# IBC — General

2015 GROUP A PUBLIC COMMENT AGENDA

SEPTEMBER 30 – OCTOBER 5, 2015  
LONG BEACH CONVENTION CENTER  
LONG BEACH, CA

**Example 1**

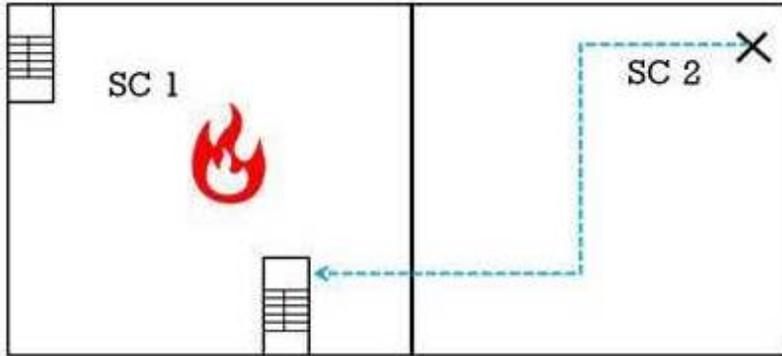
In Example 1, an occupant in smoke compartment 2 (SC2) would be forced to travel into smoke compartment 1 to access one of the two required exits for the floor. This is compliant with the current requirement that the occupant does not "return through the smoke compartment of egress origin." The smoke compartment where the mean of egress originates is smoke compartment 2. The dashed path does not leave smoke compartment 2, then RETURN back into smoke compartment 2. While this example meets current code, it creates an unacceptable hazard by creating a "dead end smoke compartment."

The proposed language would require that one of the stairs be located in smoke compartment 2, or, that the floor plate be rearranged to create access to two adjacent smoke compartments from compartment SC2.

**Example 2**

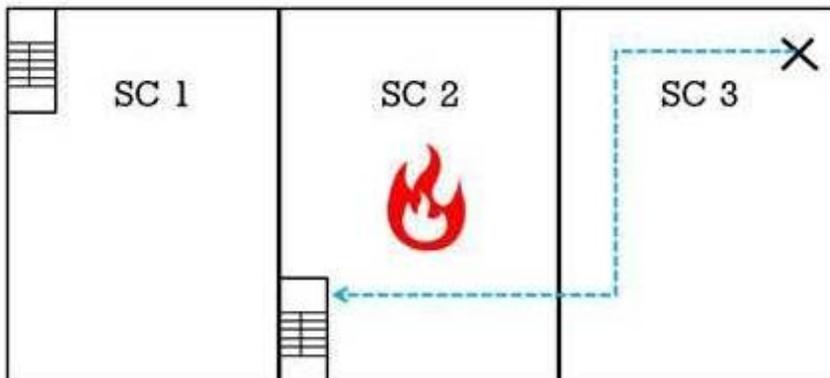
A similar condition exists in Example 2. An occupant in smoke compartment 3 would be required to travel through smoke compartment 2 to access an exit. If smoke compartment #2 has a fire, then the exiting is compromised. In this example, SC3 would be non-compliant with the proposed rule because it 1) does not have a stair, or, 2) it does not have access to two directly adjacent smoke compartments.

**Example 3**

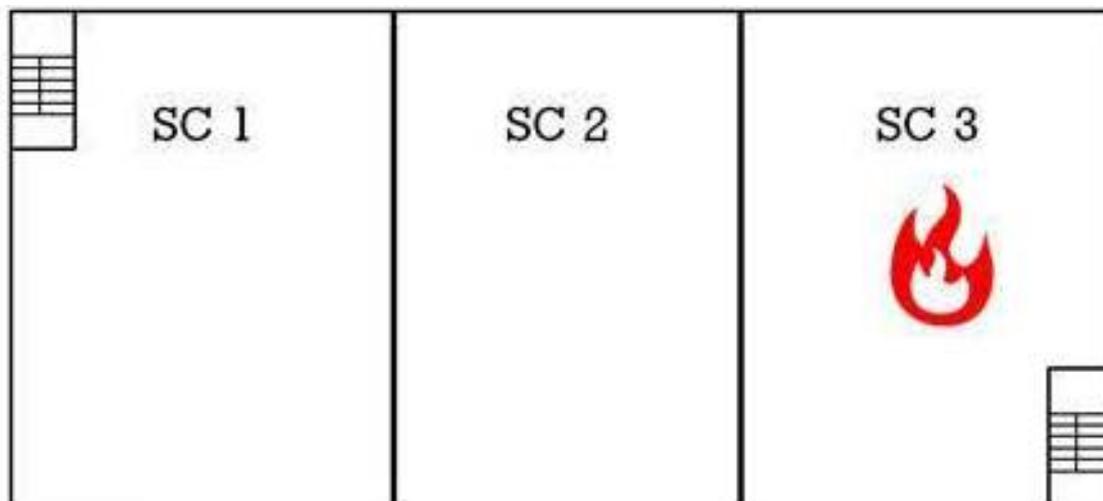
There is an easy fix to this problem: relocate the stair to smoke compartment #3 (see Example 3). That way, smoke compartments 1 and 3 have access directly to the stair, and smoke compartment #2 has access to at least two directly adjacent smoke compartments.

**Figure 1: Increase in Property Losses Due to Natural Disasters, excluding Flood<sup>1</sup>**

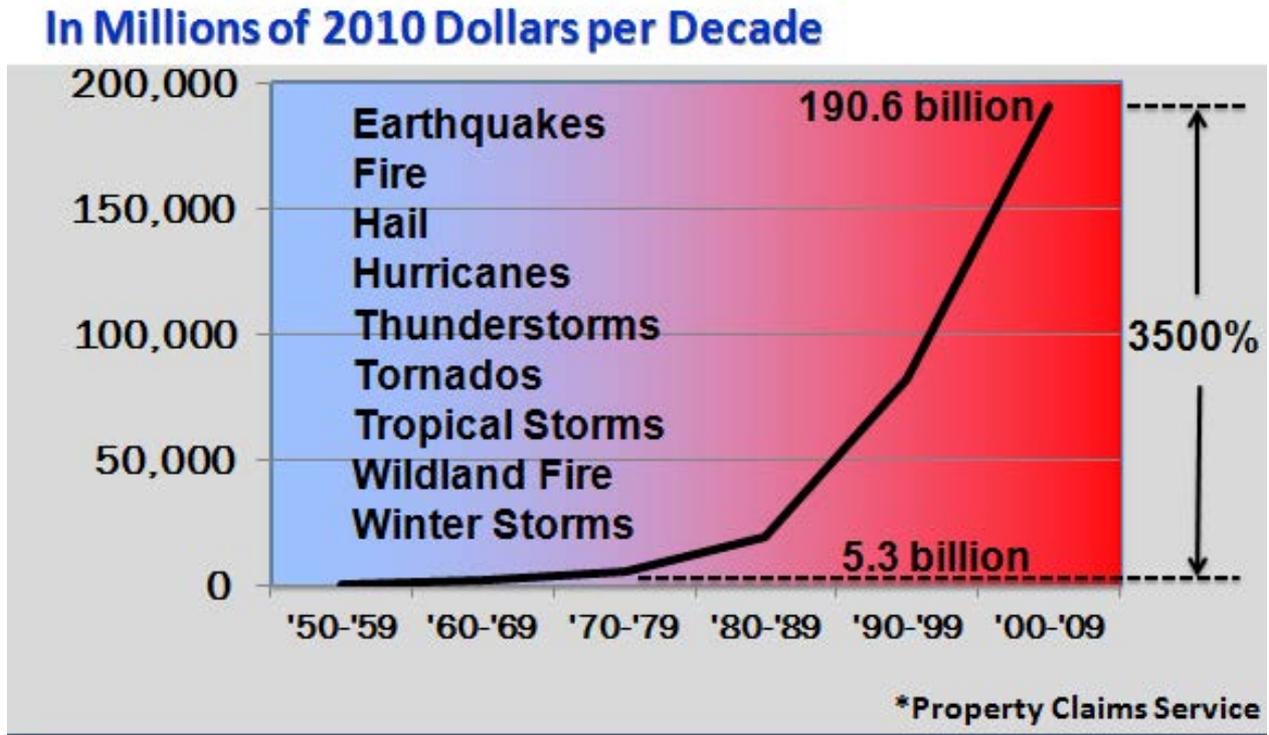
decades) or demographics (population growth even in the fastest growing regions has 10% per decade or 40% over the same time period) property losses due to natural disasters, adjusted to 2010 dollars, have increased by over a staggering 3500%, see Figure 1. Losses from fire, adjusted to 2010 dollars, have increased by 85% per fire, see Figure 2.

**Damage to siding and sheathing as a result of high winds.**

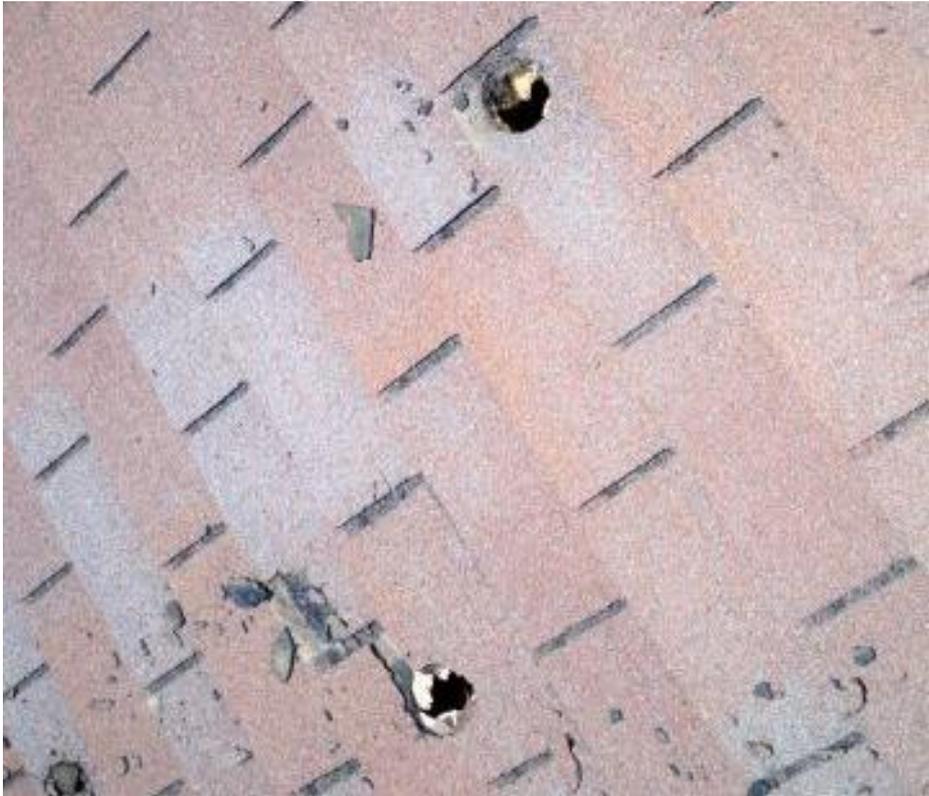
**Wind Damage - Attachment:**
